- Wiltshire councils SFRA which is the online arcgis, live version of the document has flooding maps that show the extent of flooding based on historic floods rather than modelled estimates.

- Despite the EA requiring a main modification in the current core strategy for Warminster that a SFRA 2 for the town be done due to the complex nature of flooding and the unknown interactions of various flood sources and topography, or the capacity and effectiveness of current flood management infrastructure to cope with current demands on it, let alone those increases due to climate change, this has not been done.

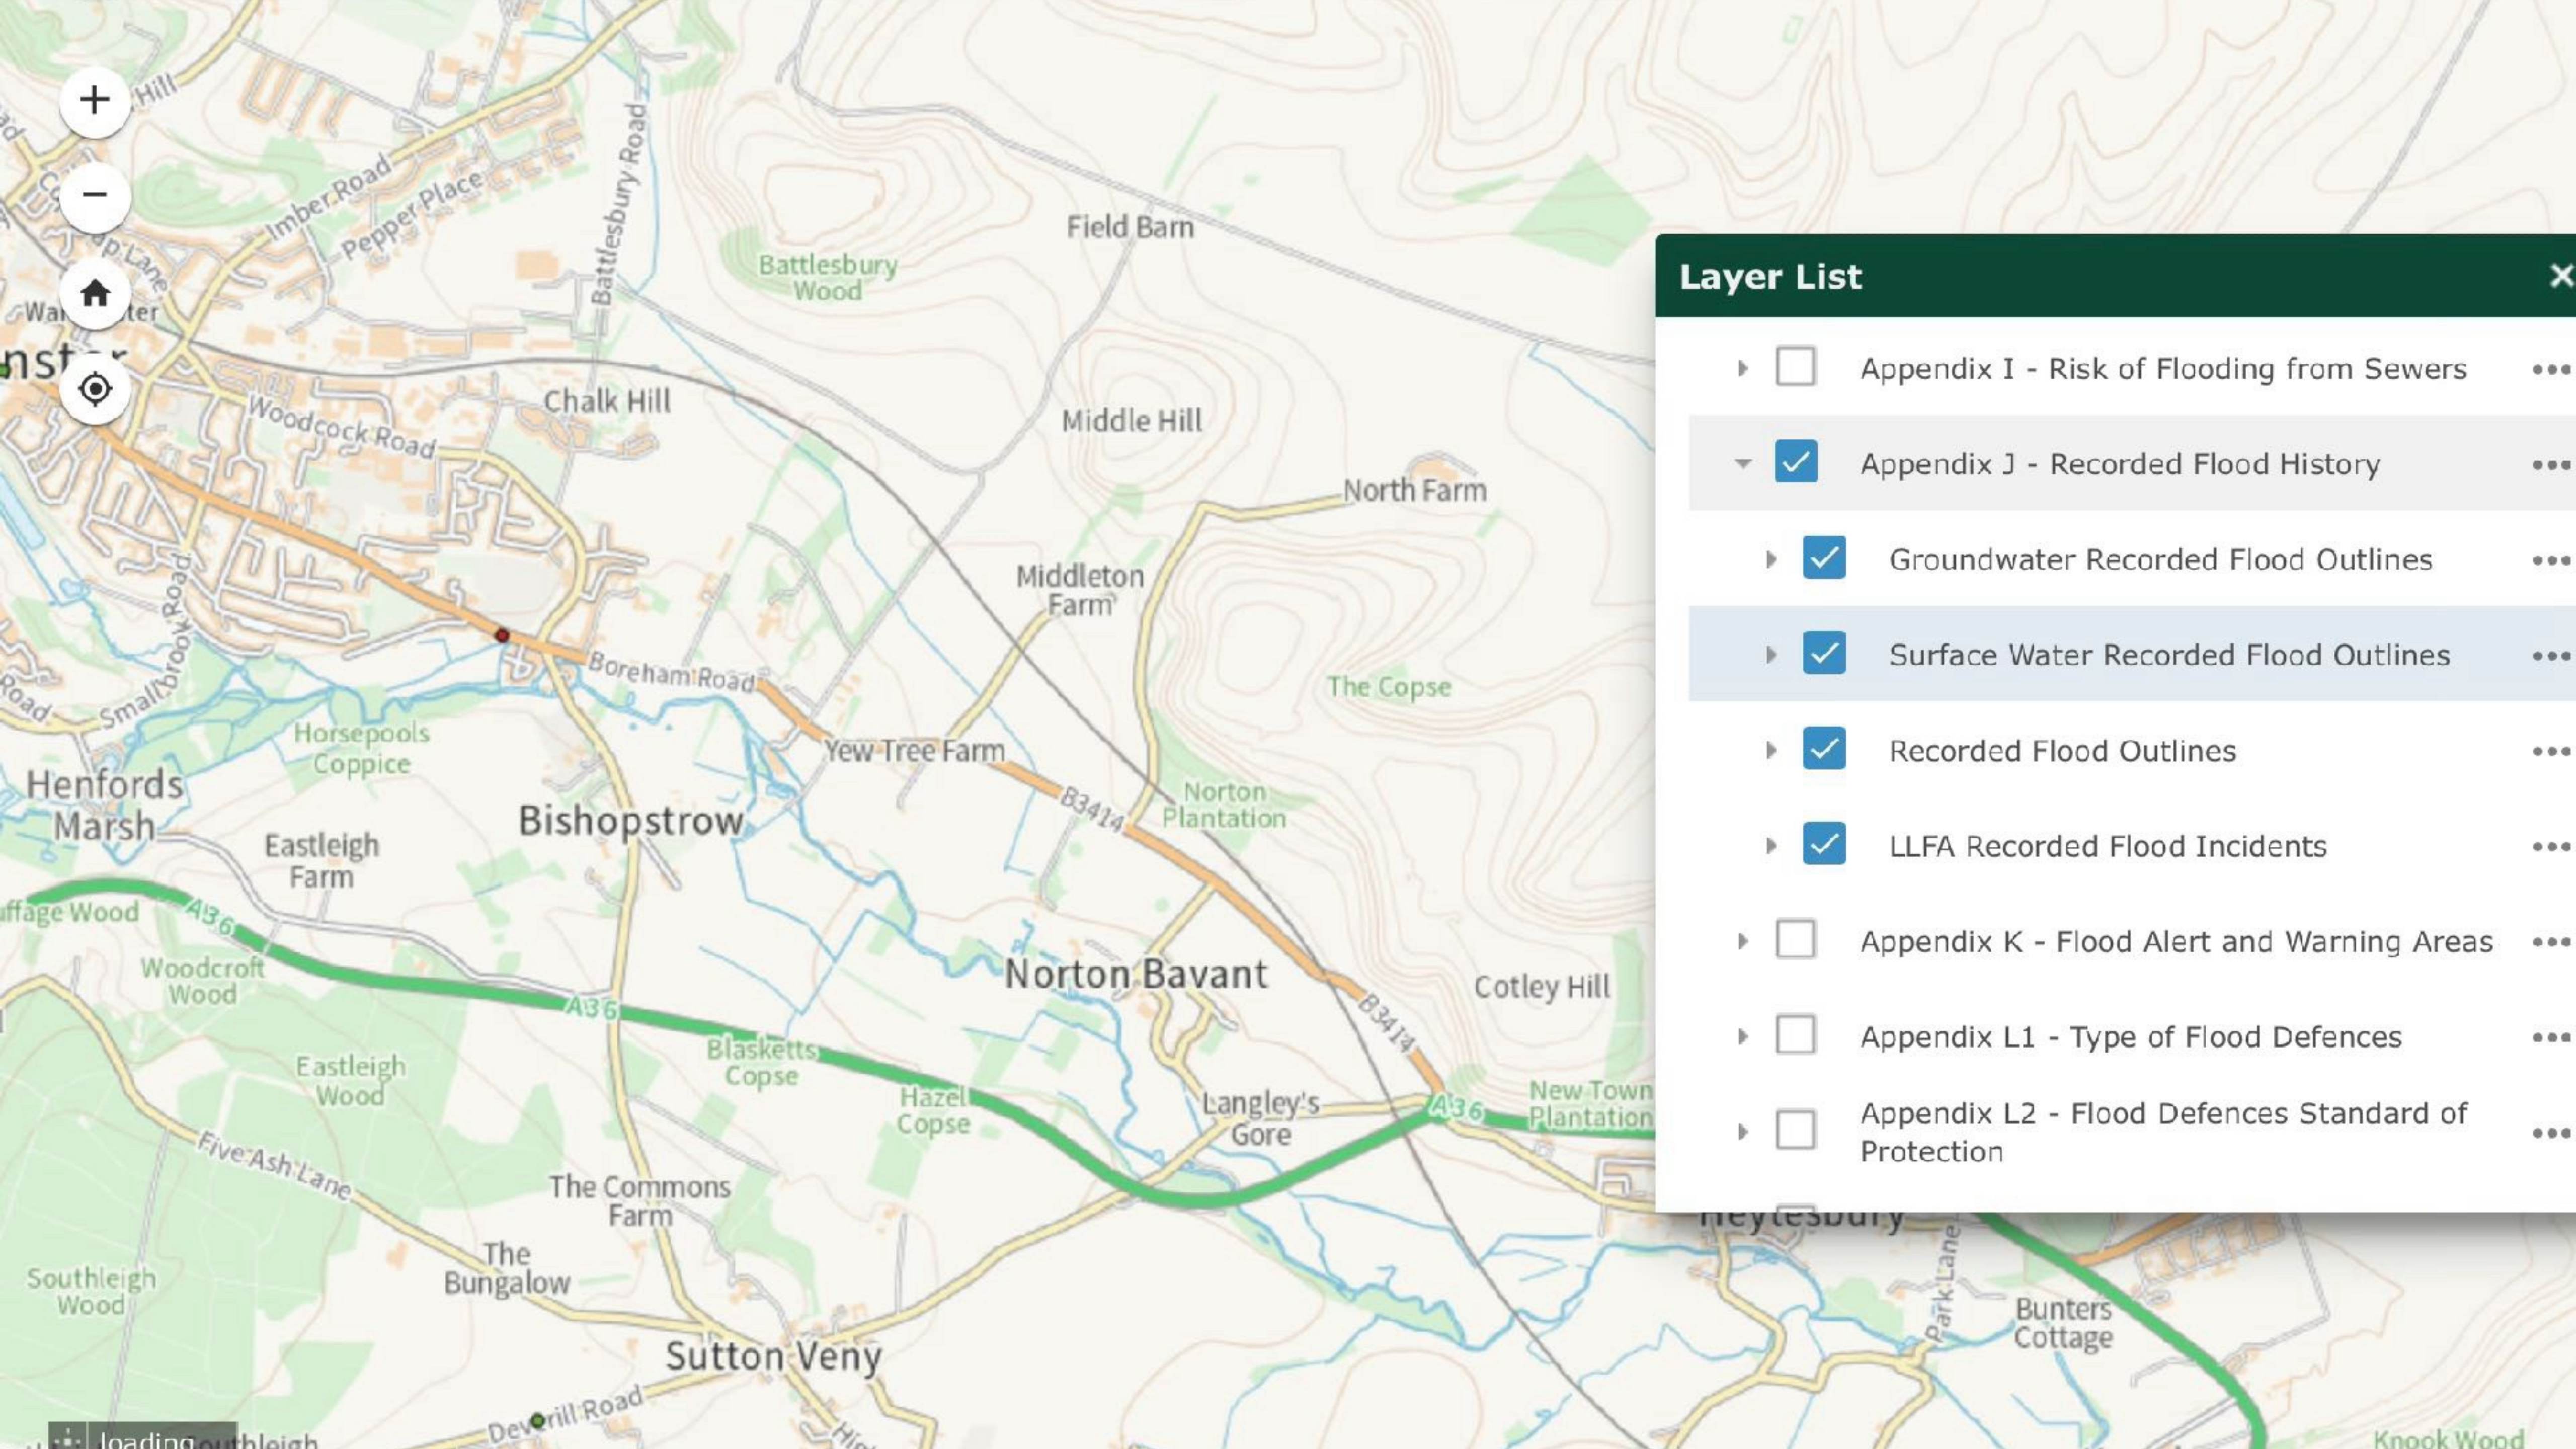
- The above map is a zoomed in version of the previous one and shows the area going from well mapped to almost devoid of anything.
- As far as I am aware this has not triggered any assessments, flood risk policies or any overt action to rectify this situation, leaving Warminster vulnerable to additional inappropriate developments and increased flood risk, which will lead to increased insurance costs which for new homes in high risk areas may be untenable as flood RE insurance reductions don't cover houses built after 2009.

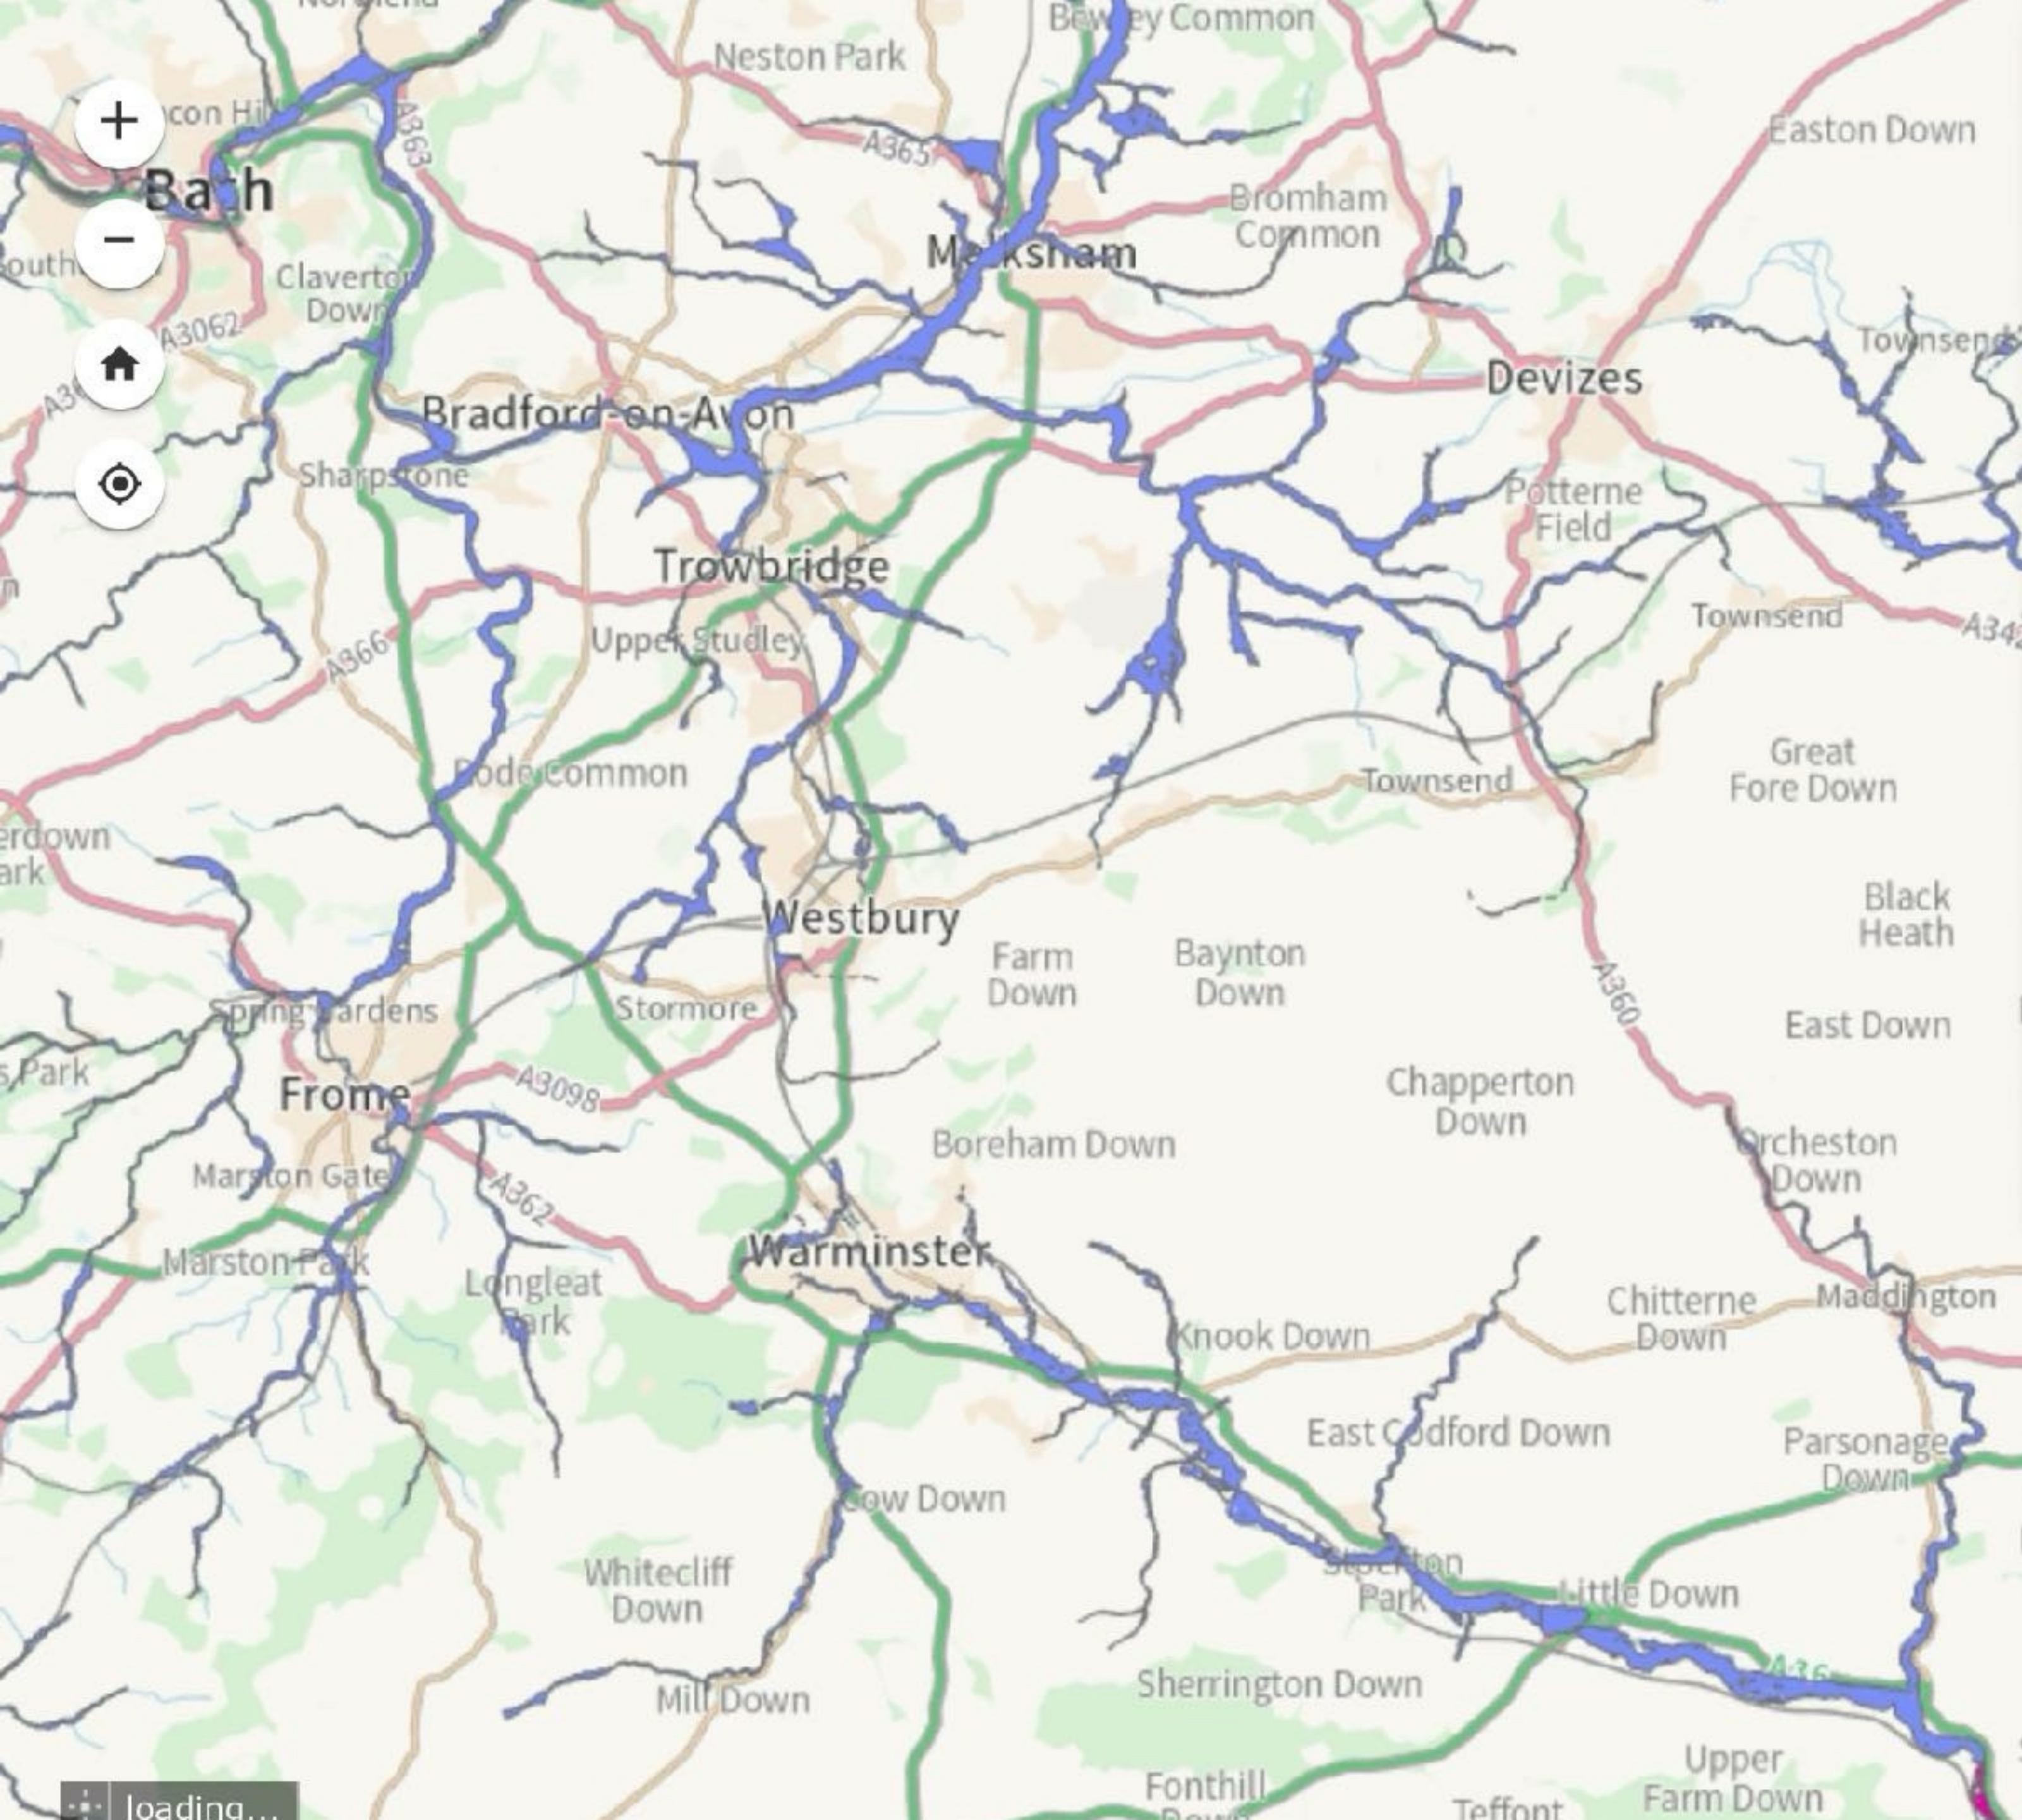
- As the above map shows Bishopstrow is also devoid of any historic flood data and as such is being used as the dumping ground for all Warminster's excess water despite it already being at or above capacity.
- Unlike Warminster, Bishopstrow doesn't even have any point data for individual floods despite many occurring and being reported so why is this?
